Howell Township
251 PREVENTORIUM ROAD
PO BOX 580
HOWELL, NJ 07731

Date Issued 9/30/2011
Control Number C-15593
Permit Number 20110961
Permit Issue Date 5/13/2011
Certificate Number 20110961

Description of Work/Use: POLE BARN

C15593

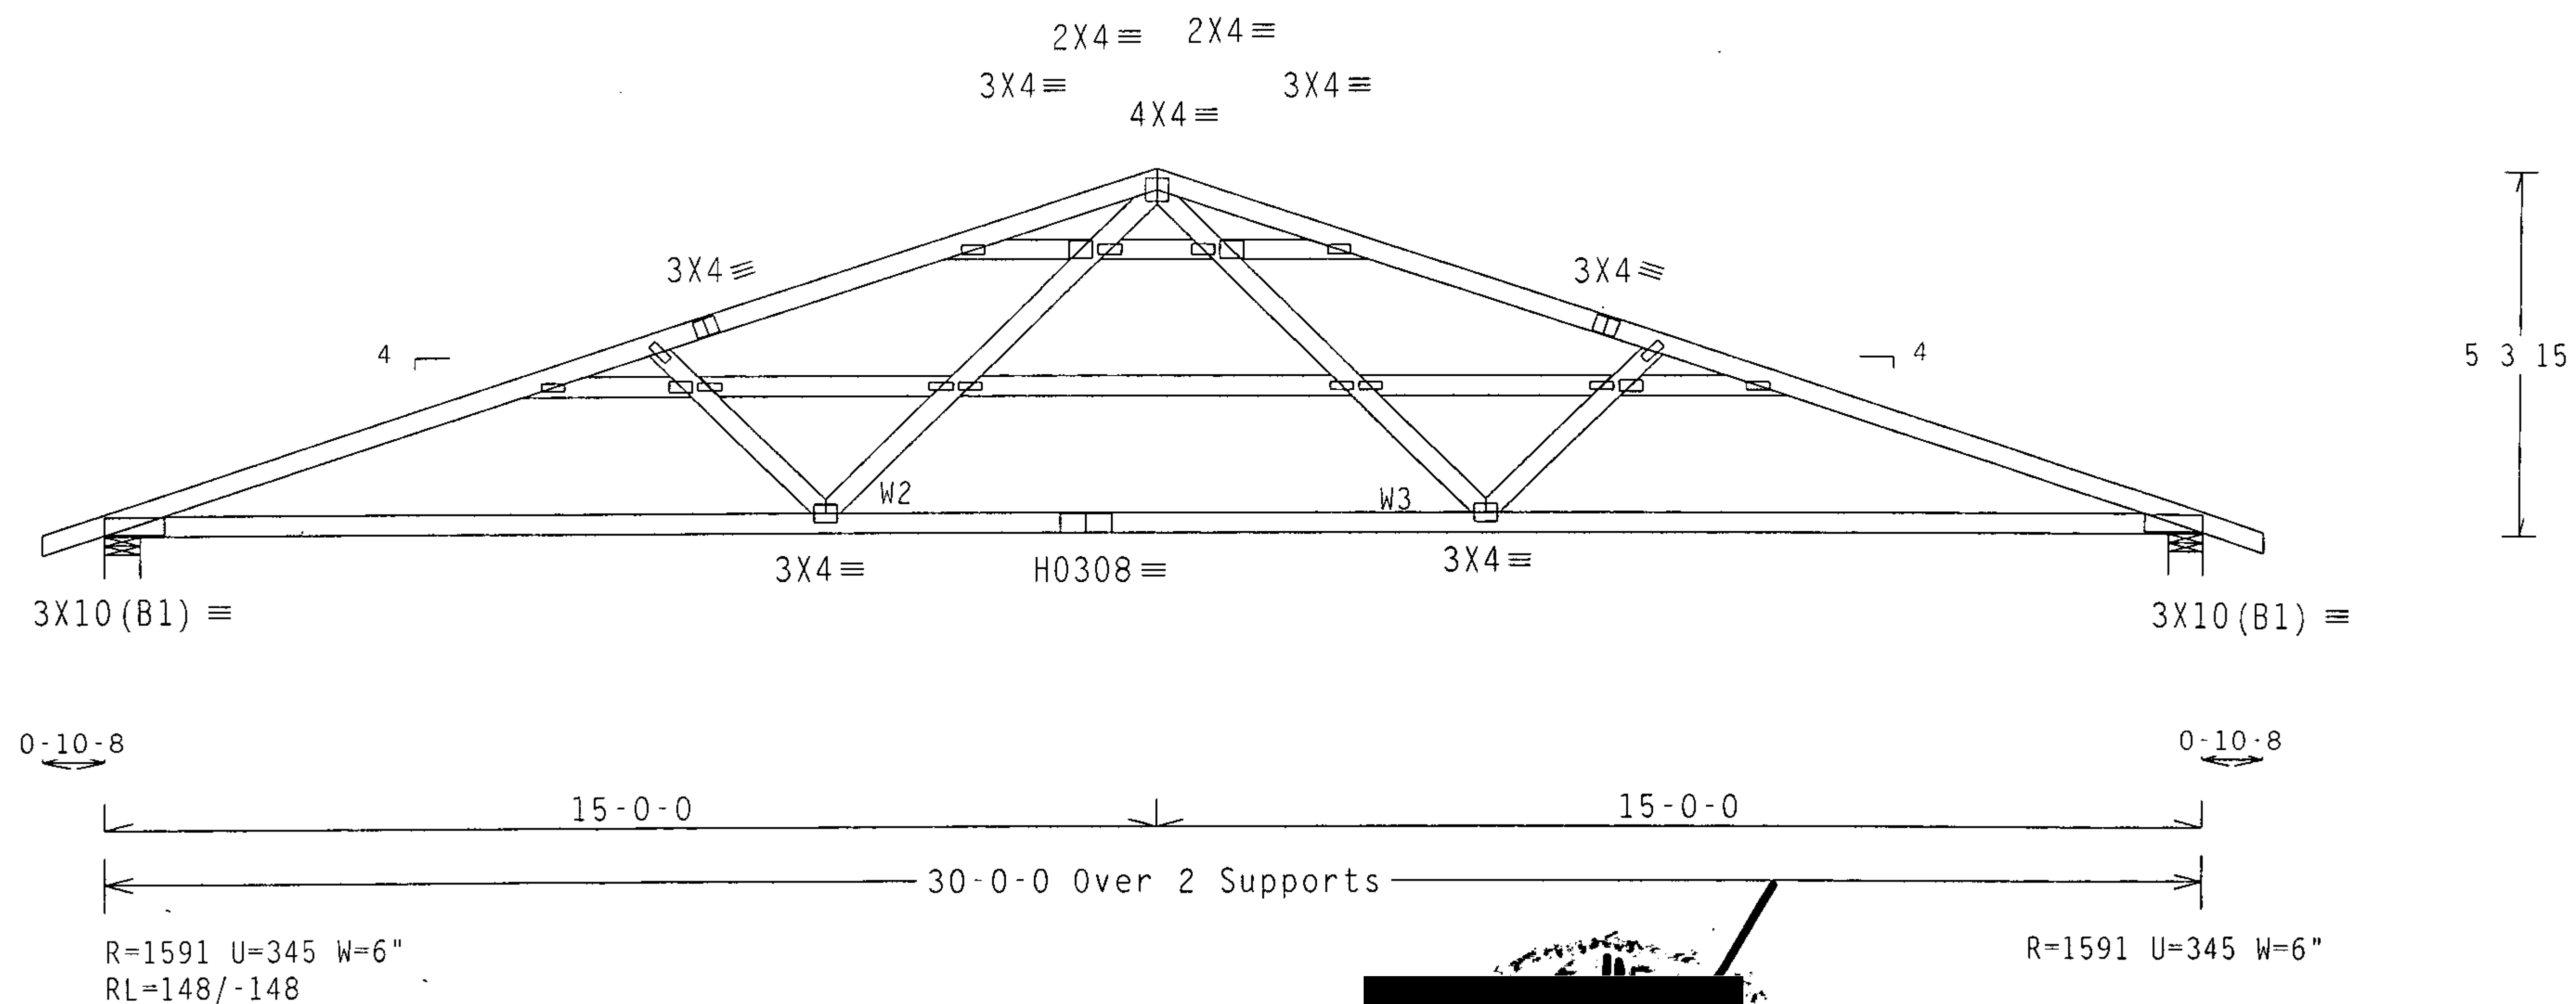
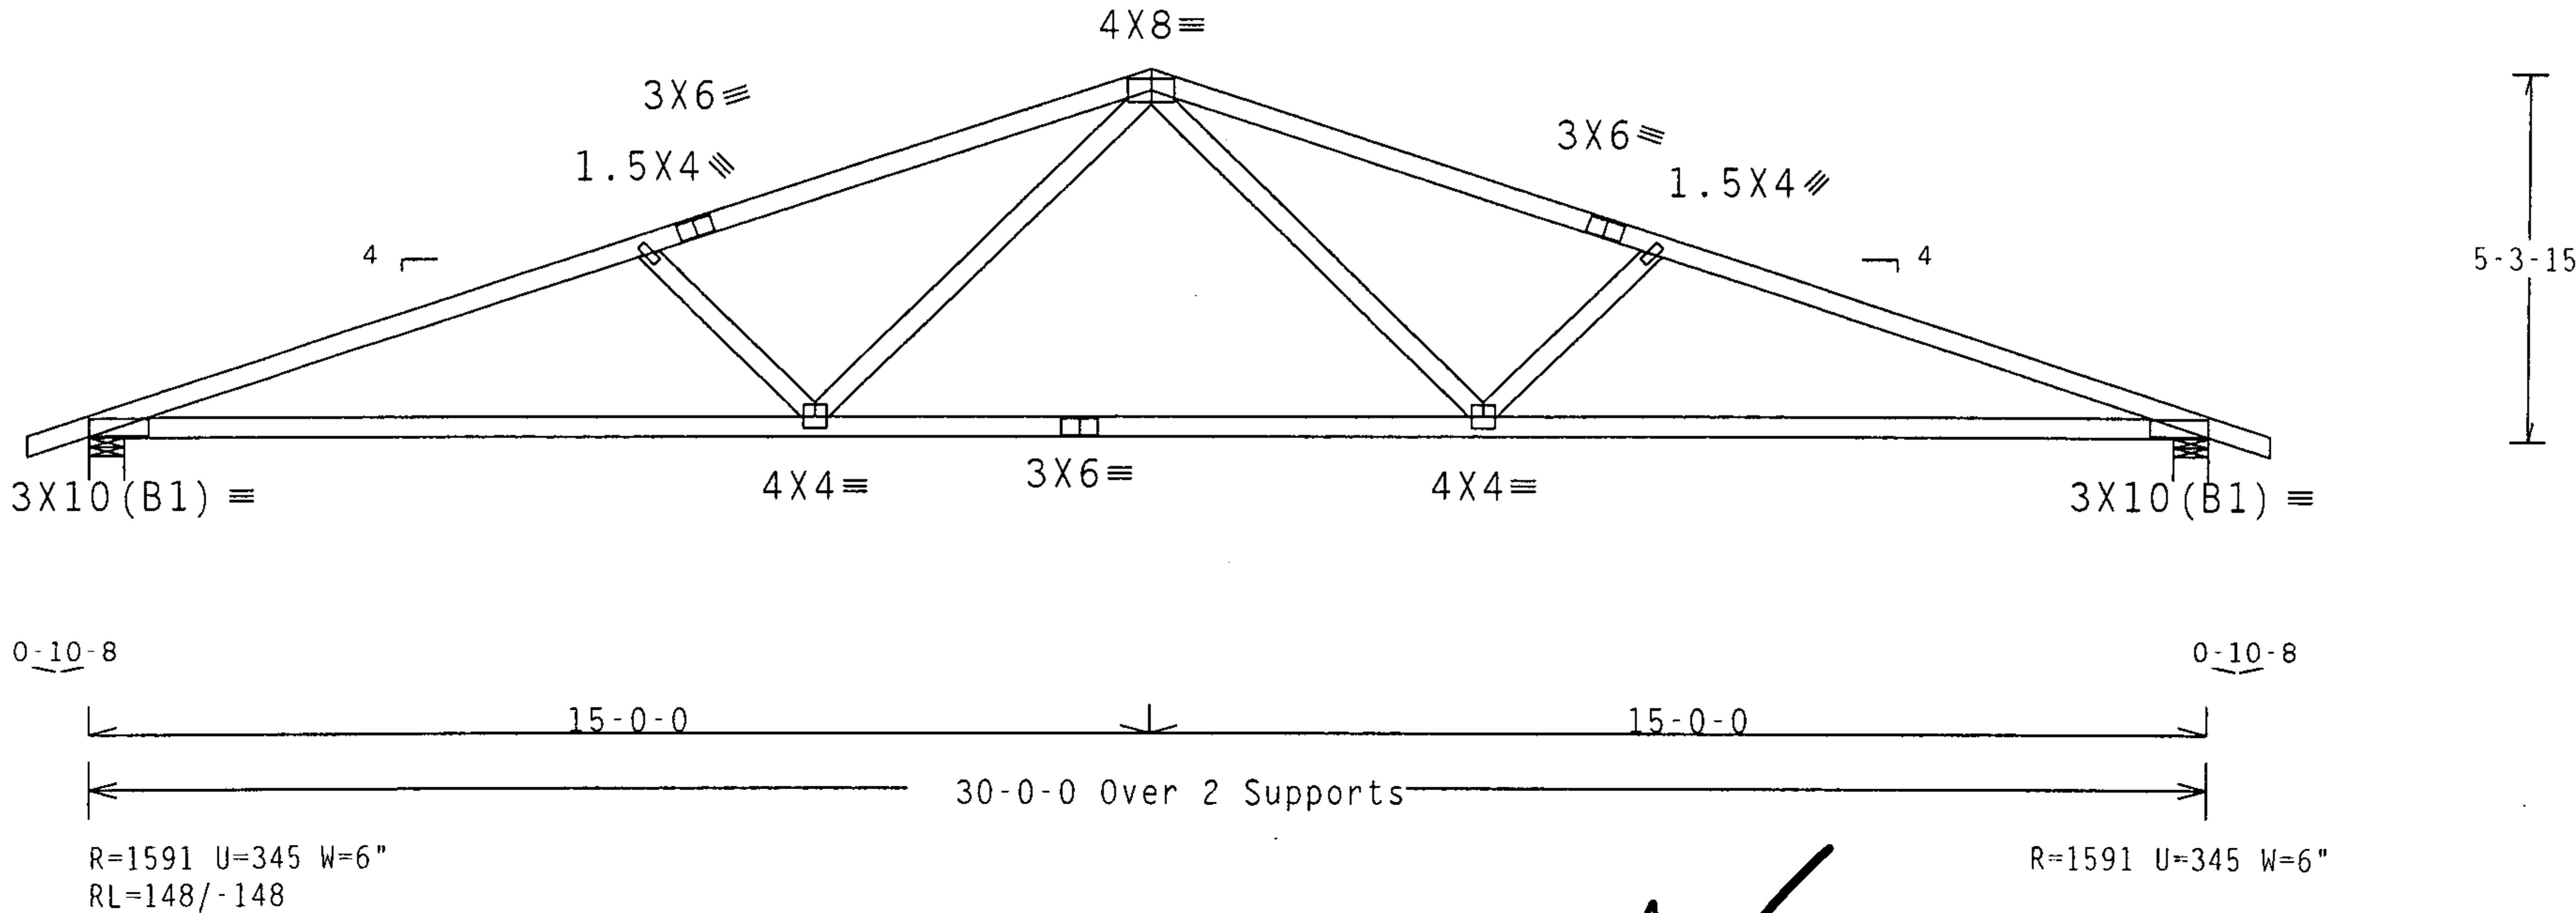
The following comments were made during the Plan Review process:

- ☒ 1. Need specific gable end truss drawing. (sealed)
- ☒ 2. Need 2 sealed copies of truss drawings.)
- ☒ 3. Need permanent lateral truss bracing plan designed by building designer not truss company. (2 copies)
